## SUBMISSION ON THE WORKS APPROVAL FOR THE RAISING OF LONDON CIRCUIT

The Public Transport Association of Canberra (PTCBR) welcomes the opportunity to make a submission to the works approval applications associated with the project to raise London Circuit.

**Figure 1:** Possible locations for additional bus stops

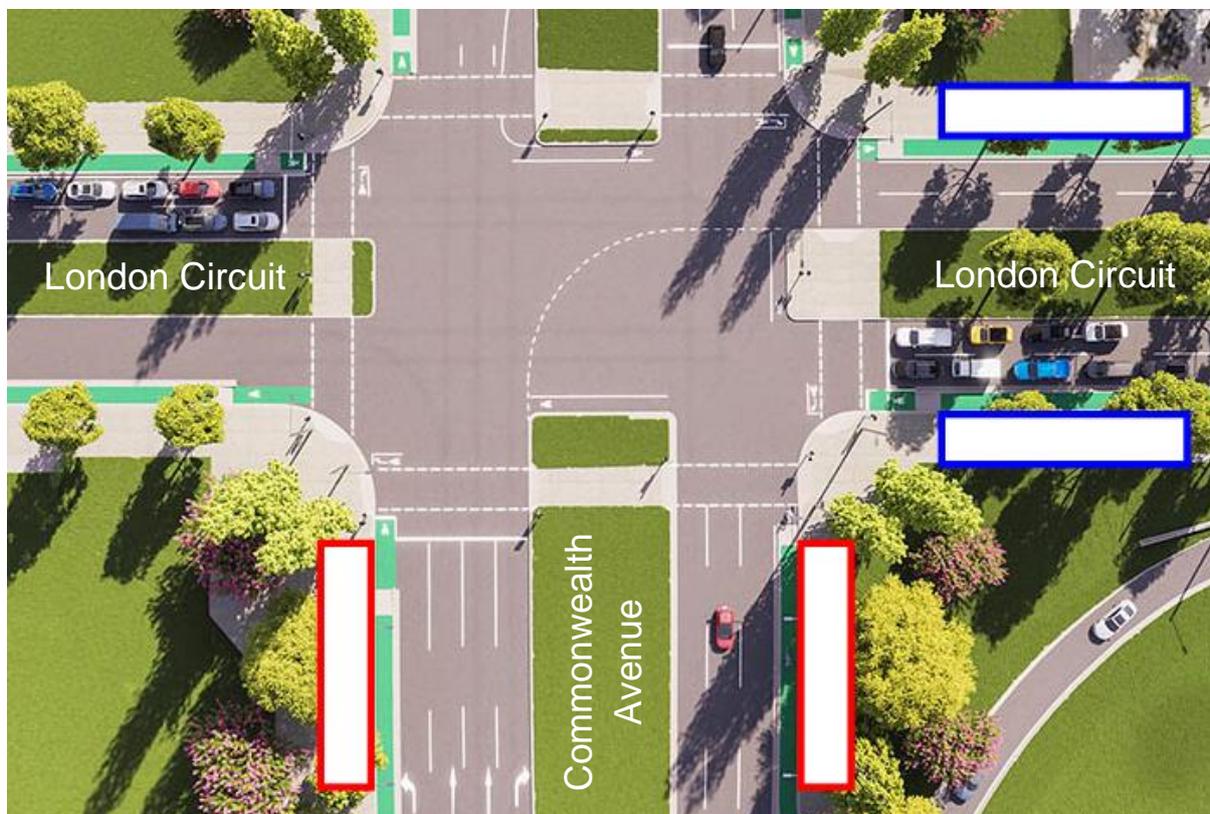
First, there is a need for additional bus stops to serve the planned residential and commercial developments around the new intersection, as well as the existing poorly served precinct around QT and NewActon. The current plans make no allowance for this, other than the planned light rail stop, leaving the closest bus stops over 800 metres away at the Legislative Assembly.

PTCBR proposes that additional bus stops be constructed either on London Circuit to the east of the new intersection (see [Figure 1](#), blue) or on the southern side of the intersection on Commonwealth Avenue (see [Figure 1](#), red). These stops should be of a suitable length to accommodate multiple buses, as per the existing stops on London Circuit.

- 1. placing additional bus stops either on Commonwealth Avenue or on London Circuit to the immediate east of the new intersection, and*
- 2. including a bus priority turning lane from Commonwealth Avenue northbound onto London Circuit.*

**Figure 3:** Anticipated traffic impacts during construction

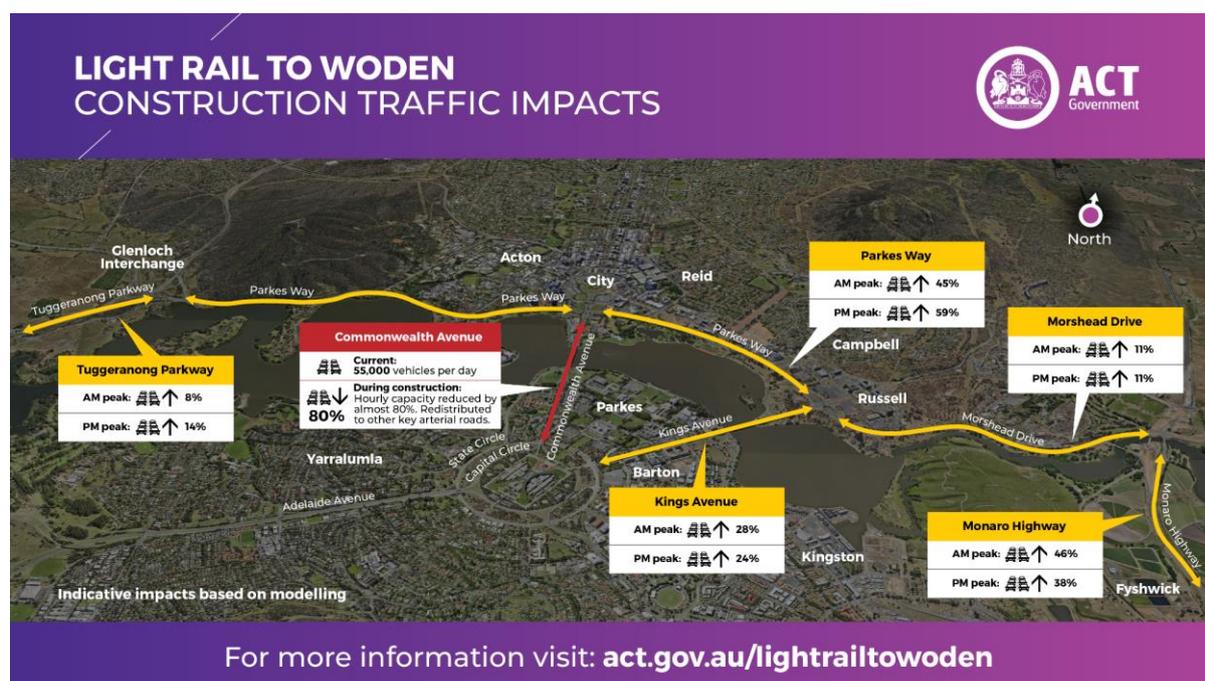
PTCBR notes, however, that the project’s assessment is significantly more optimistic than the forecasts provided by the ACT Government’s Disruption Taskforce, which assume that the capacity of Commonwealth Avenue will be reduced by 80 per cent during construction (see [Figure 3](#)).<sup>3</sup>

In response to those forecasts, PTCBR has called for the consideration of significant bus priority measures, such as making Commonwealth Avenue bus only, in order to maintain the flow of people into Canberra City.<sup>4</sup> Such measures may not be necessary under the more recent modelling undertaken for this project, however the Transport and Traffic Liaison Group (TTLG) should continue to monitor bus travel times and take action if they deteriorate significantly, consistent with the proposed T7 and T10 mitigation measures.<sup>5</sup>

**Recommendation 2** – *The Transport and Traffic Liaison Group should monitor the impact of the construction works on bus times and be prepared to implement additional bus priority measures if the delays become unacceptable*
